Brookside Village Road Evaluation Prepared for Gerald Herman

On the morning of 8/30/2021 the Public Serves Director, Public Works Manager, and Jason Reynolds from CSR Engineering conducted forensic road observations at Brookside Village based on a study session conducted on August 19th at 6:00pm.

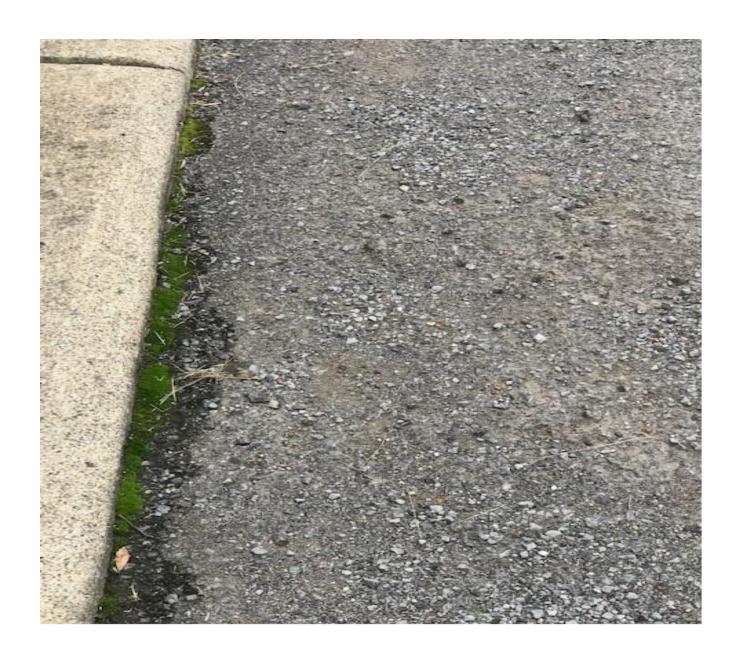
Shoving: Shoving is the formation of ripples across a pavement. This characteristic shape is why this type of distress is sometimes called wash-boarding. Shoving occurs at locations having severe horizontal stresses, such as intersections. It is typically caused by: excess asphalt; too much fine aggregate; rounded aggregate; too soft an asphalt; or a weak granular base.

FIX: Partial or full depth patch
